UNITED STATES
NUCLEAR REGULATORY COMMISSION
WASHINGTON, D. C. 20555

APPLICANT: Public Service Electric & Gas Company (PSE&G)
FACILITY: Hope Creek Generating Station
SUBJECT: SUMMARY OF STRUCTURAL AND GEOTECHNICAL ENGINEERING
BRANCH (SGEB) MEETING

On August 1, 1984, a meeting was held in the Bethesda, Maryland offices of the NRC to discuss the remaining SGEB-Structural audit open items identified in the Draft SER. A list of meeting attendees is included as Enclosure 1 to this meeting summary.

FIGURE A-13-14
 RESPONSE SPECTRA COMPARISON,
 AUXILIARY BUILDING AT ELEV. 54'-0"

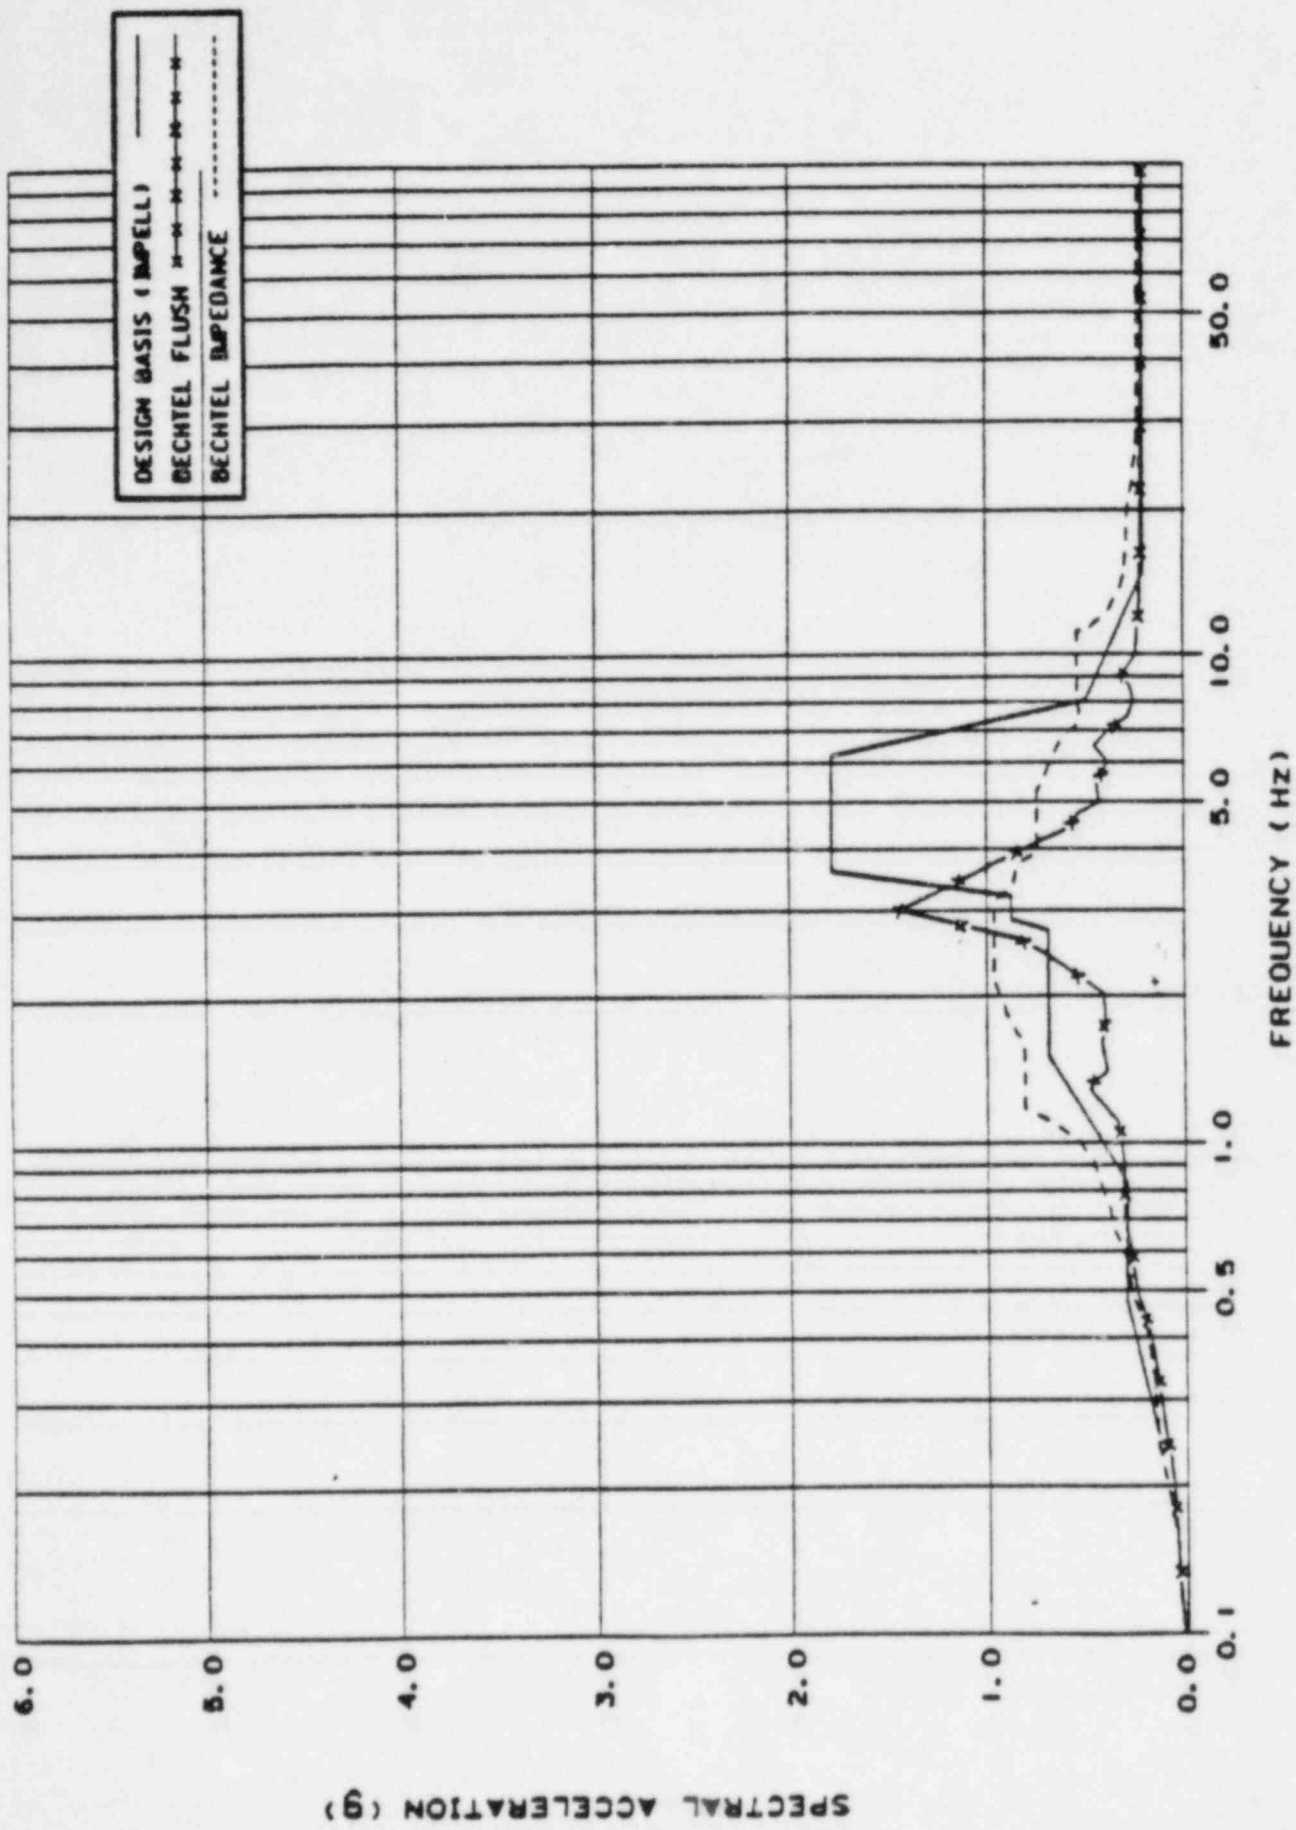
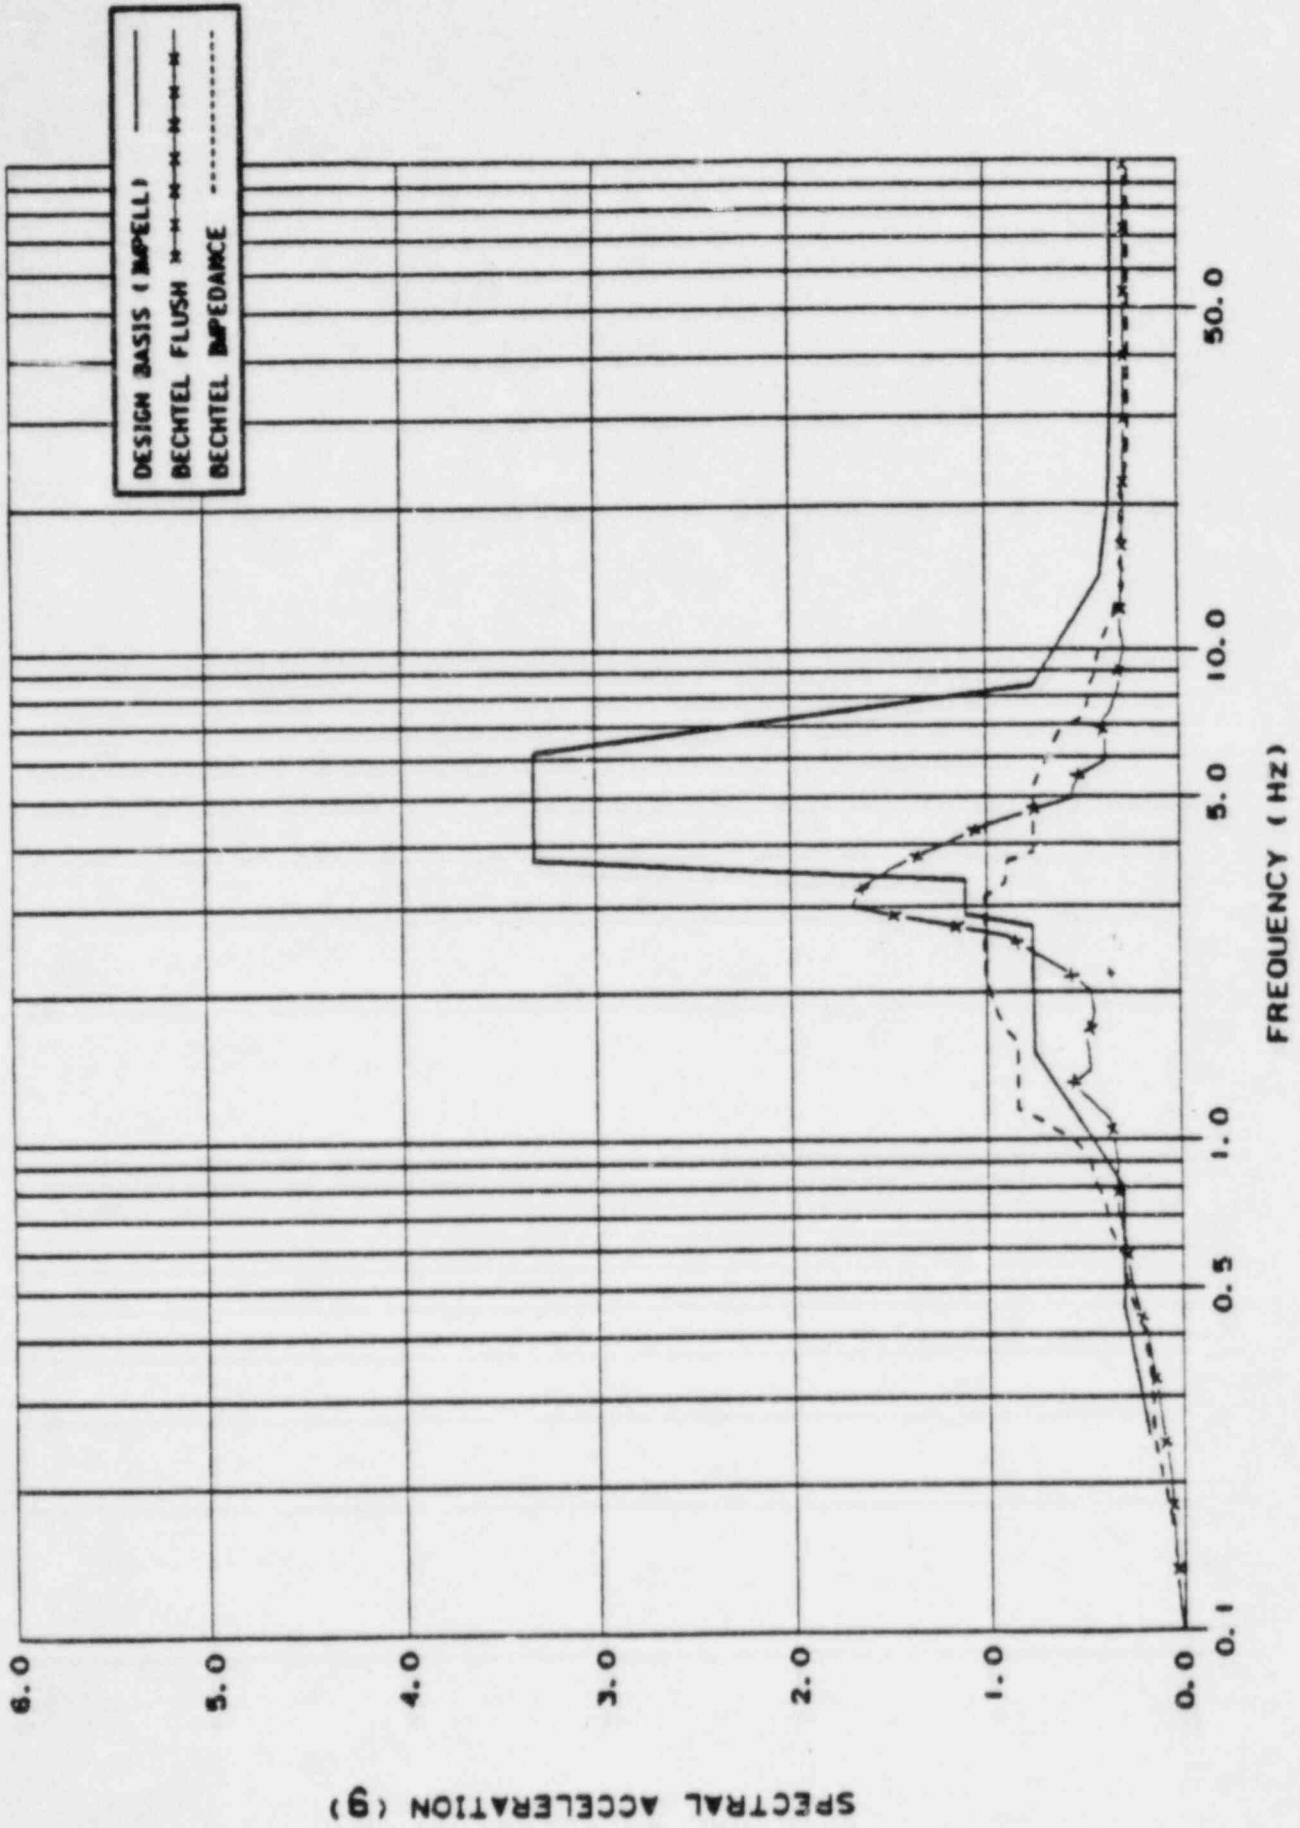
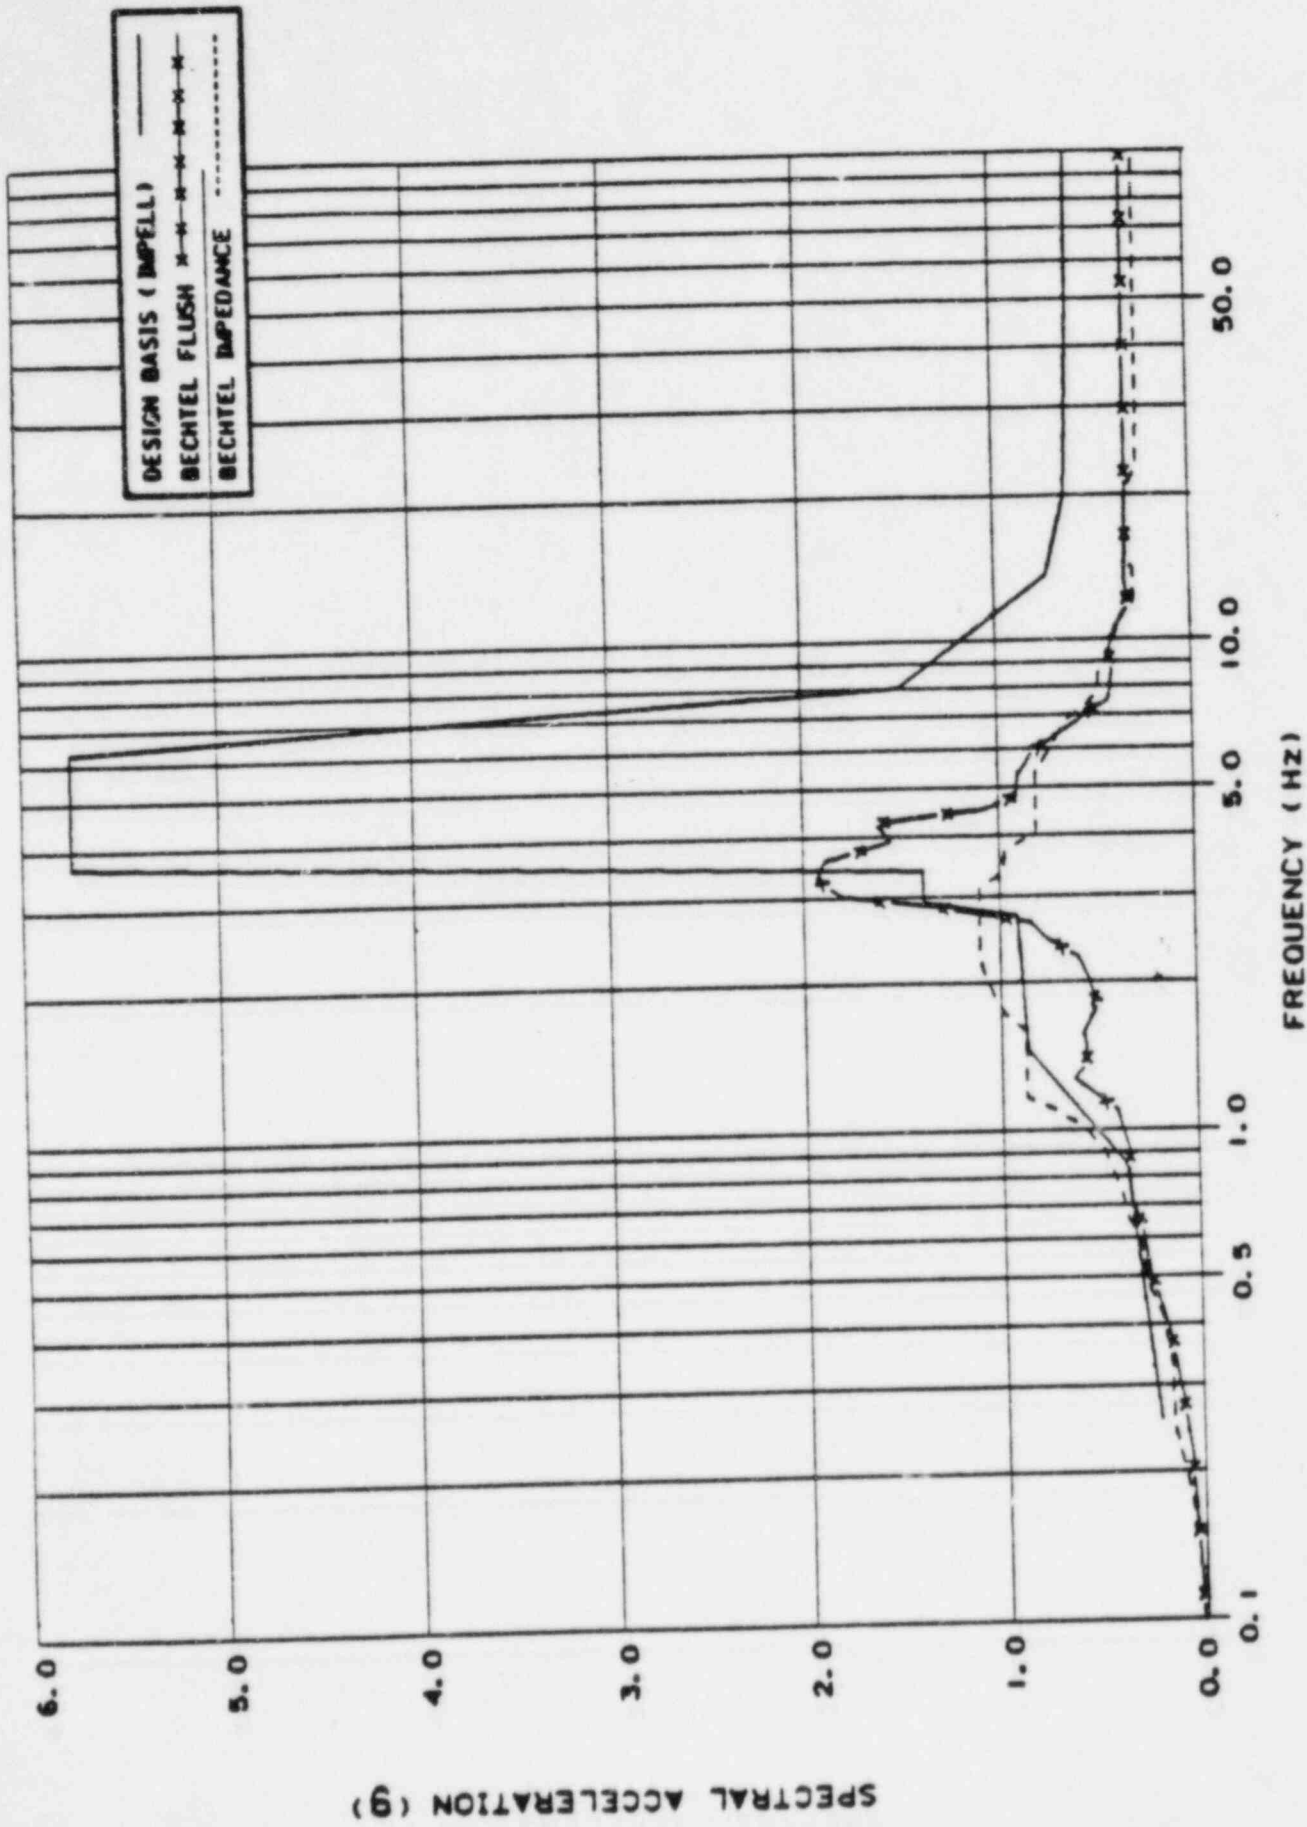
Question: Provide comparison of Bechtel Independent Verification Results with the Design Basis Results.

Figures A-13-2 to A-13-37 show the comparison of the response spectra (2% damping) obtained from the above three seismic soil-structure interaction analyses. Discussions of these comparisons are as follows:

Bechtel's independent soil-structure interaction analyses are performed using the computer code FLUSH. The results of independent finite element analyses are in reasonable agreement with those of the design basis analyses. As can be seen from Figures A-13-2 through A-13-37, the horizontal response spectra obtained from the independent finite element analyses are generally enveloped by those obtained from the design basis analyses except for the frequency range lower than 2 Hz. The vertical response spectra showed some exceedances at the frequency range of 18 Hz. These exceedances are listed in Table A-13-1.

The peak spectral accelerations obtained from the impedance approach analyses are generally lower than those obtained from the design basis analyses. However, these response spectra are not completely enveloped by those obtained from the design basis analysis, especially in the frequency range between 1.0 and 3.5 Hz. Also, there are some local exceedances in the higher frequency range, as shown in Figures A-13-2 through A-13-37.
